City of Portland, Maine – Building or Use Permit Application 385 Congress Street, 04101, Tel: (207) 874-8703, FAX: 874-8716

Location of Construction: 88 Federal St 2nd fl		Owner: Roman Catholic Church		Phone:		Permit No: 981402	
Owner Address: 88 Federal St Portland		Lessee/Buyer's Name: Pine Tree Legal		Phone: 774-4753		Business Name:	
Contractor Name: Jewell Associates, Inc.		Address: P.O. Box 6610 Portland 04103		Phone: 774-4755		* ← Steve	
Past Use: Office		Proposed Use: Office		COST OF WORK: \$ 76,000		PERMIT FEE: \$ 150.00	
				FIRE DEPT. <input checked="" type="checkbox"/> Approved <input type="checkbox"/> Denied		INSPECTION: Use Group: B Type: 3B	
				Signature: [Signature]		Signature: [Signature]	
Proposed Project Description: Renovate 2nd floor into offices, add windows (4) 1 egress door & external Metal stairs				PEDESTRIAN ACTIVITIES DISTRICT (P.A.D.)			
				Action: <input type="checkbox"/> Approved <input type="checkbox"/> Approved with Conditions <input type="checkbox"/> Denied			
				Signature: _____ Date: _____

DATE: 6 DEC, 98 ADDRESS: 88 Federal ST. CBL 028-J-001
REASON FOR PERMIT: Renovate 2nd Floor Office Space.
BUILDING OWNER: Roman Catholic Church
CONTRACTOR:

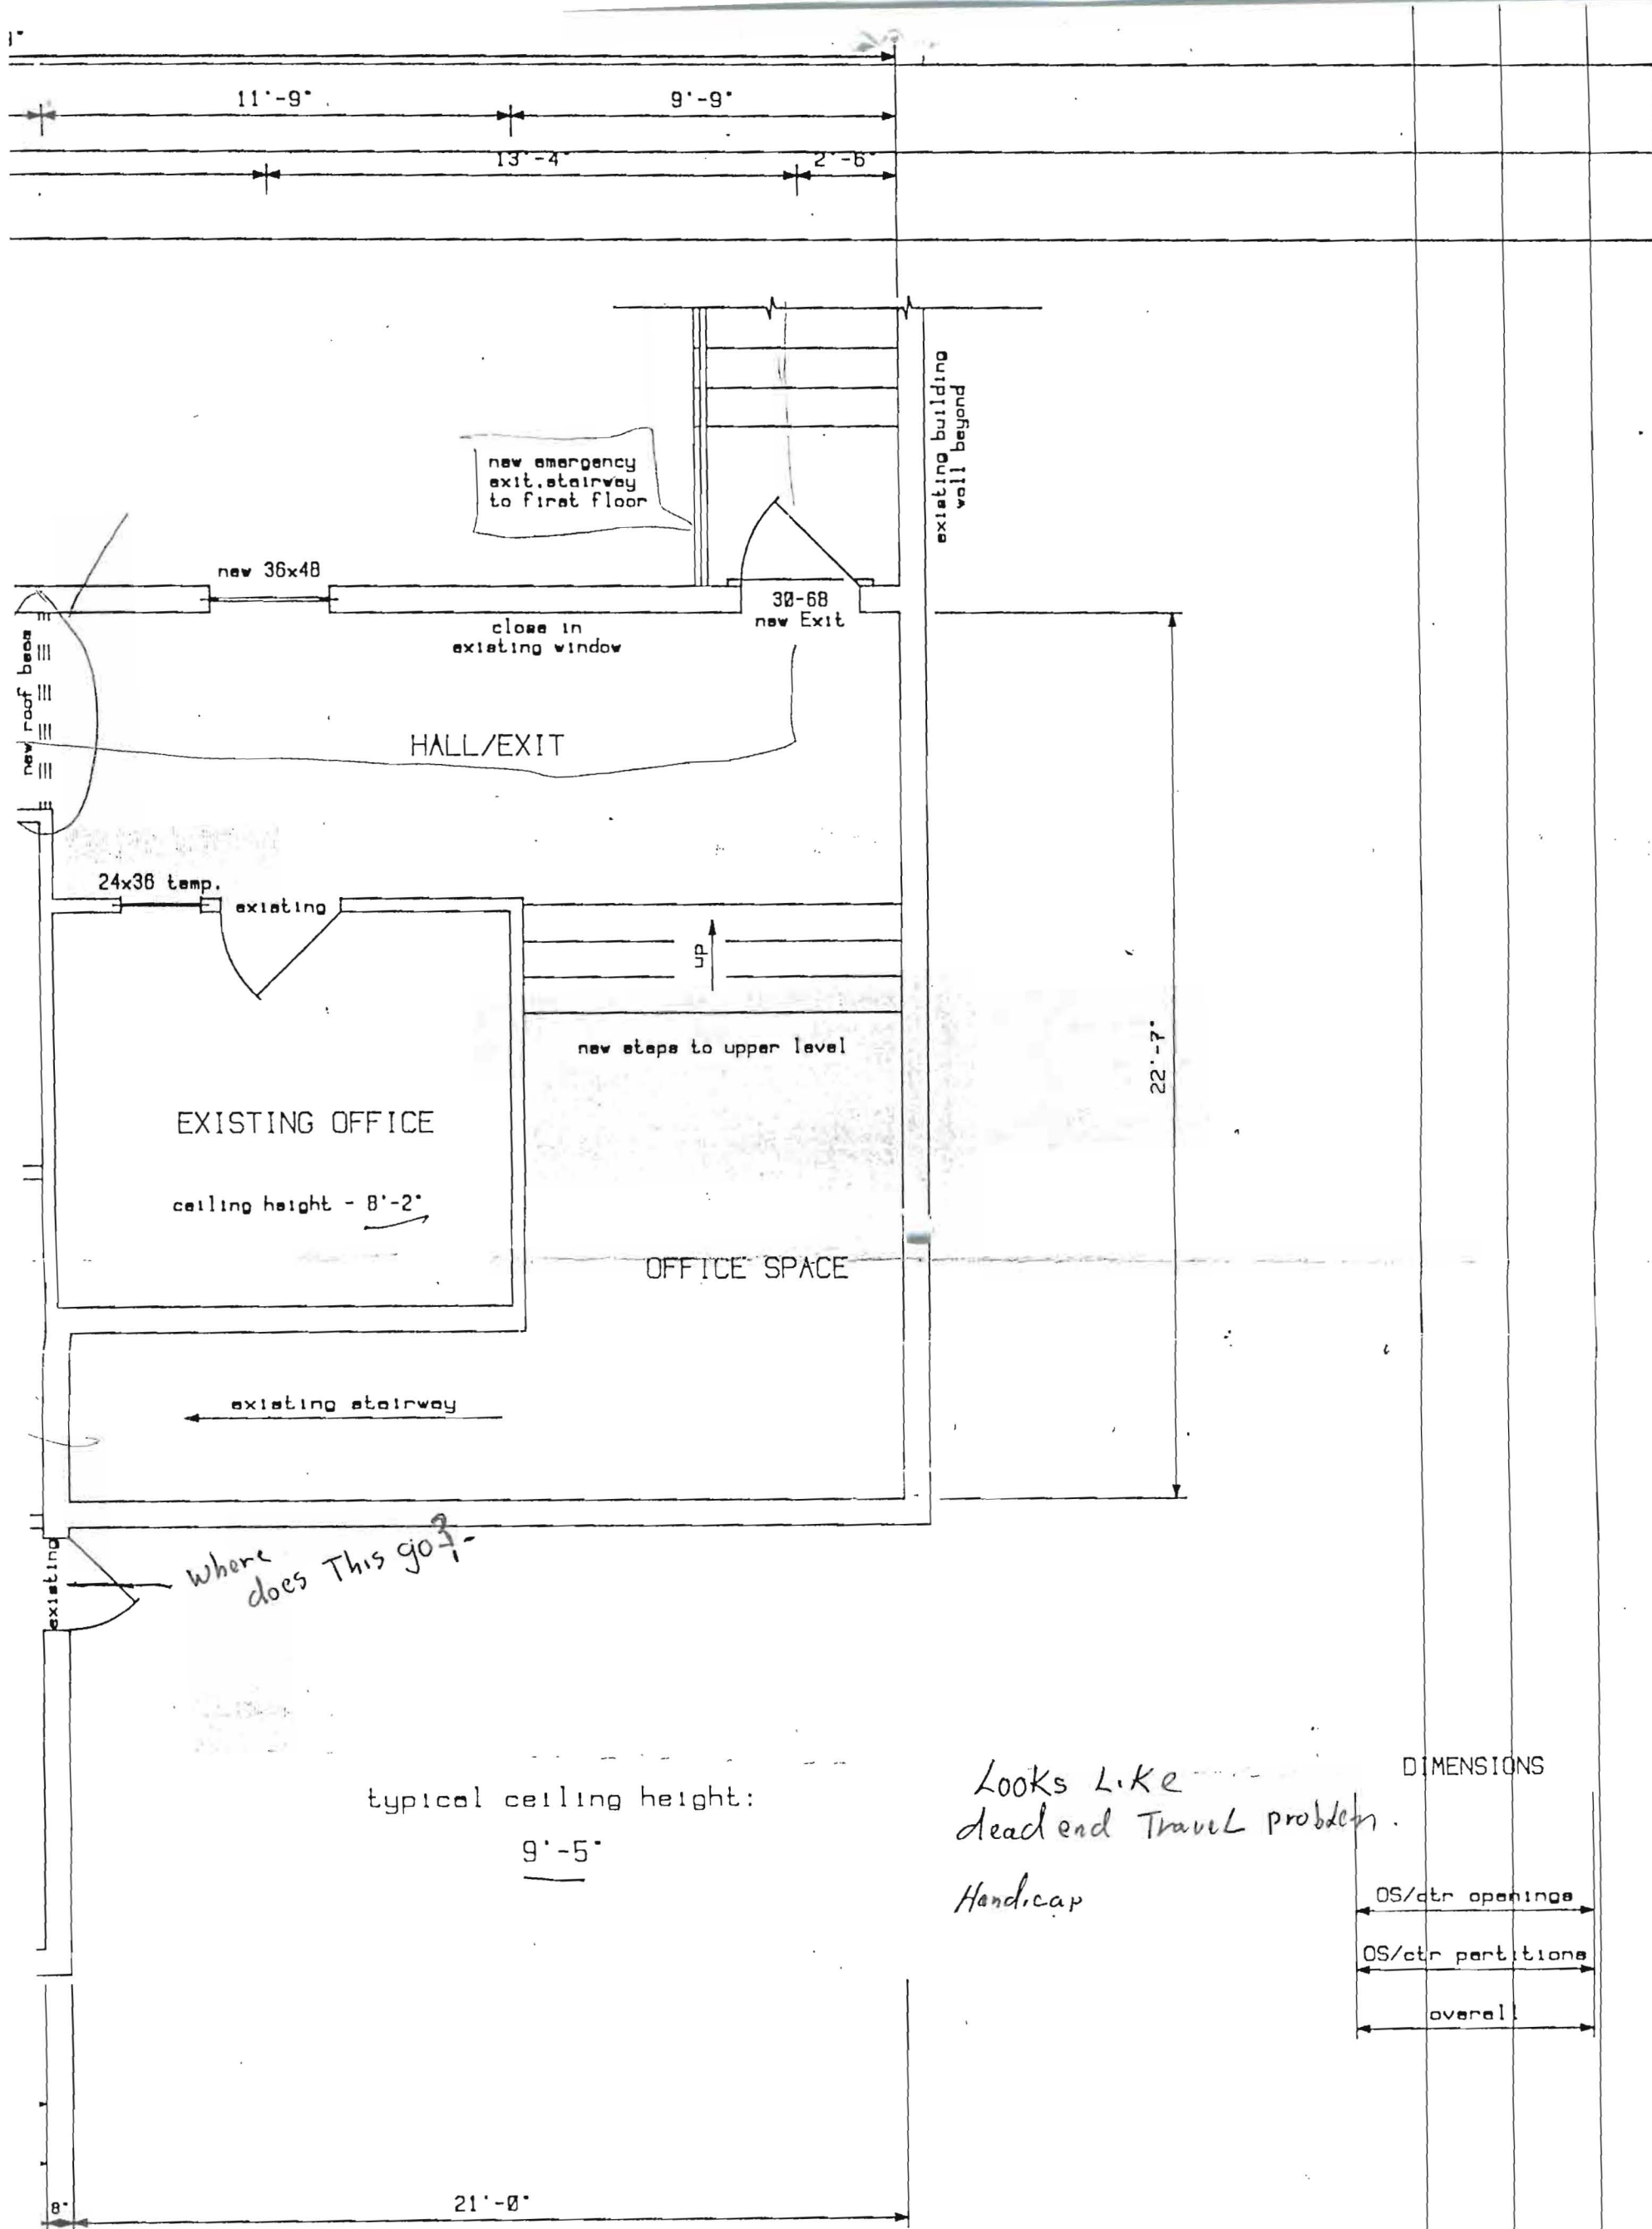
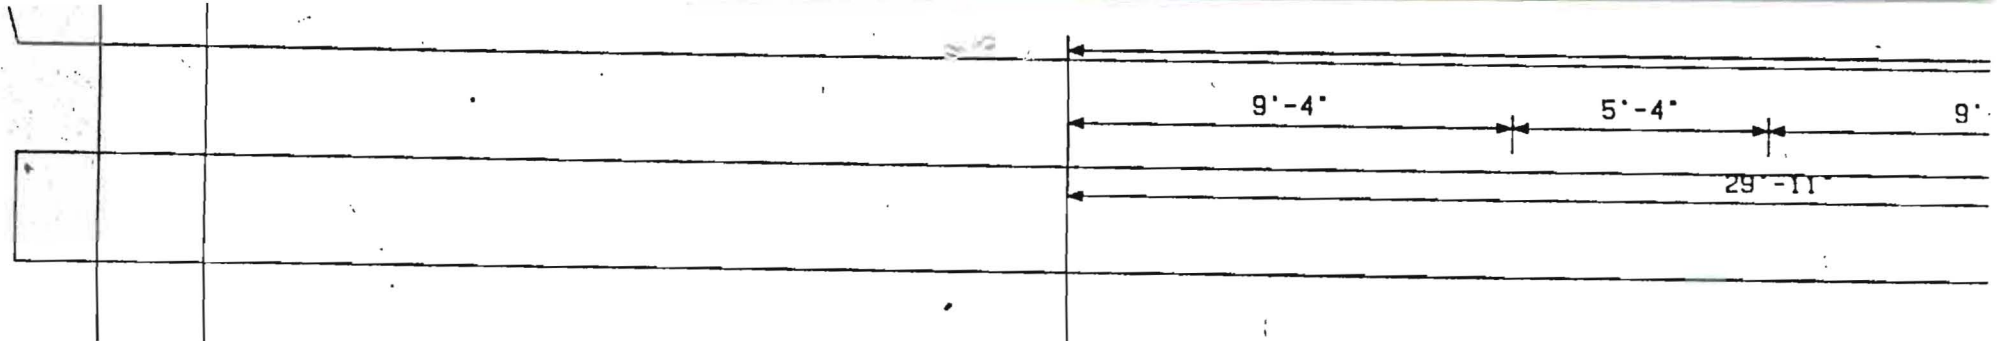
X 31. *Your plan shows new roof beam but does not give any specification or design of the beam - Please submit this information to this office for review and approval*

X 32. *Your submitted plan is not clear on Dead End Travel distances. Section 1011.2 of the City's Building Code allows only 20 feet in most cases. This issue must be resolved before work is started.*

X 33. *Your new proposed exit does not show exit discharge on your plan. Does this discharge to the exterior of the building? Please call me at 874-8704 to discuss these matters.*

*OK - BOCA called BOCA 11/8/DEC/98 one more
OK in this situation.*

Looks Like
 dead end Travel problem.
 Handicap
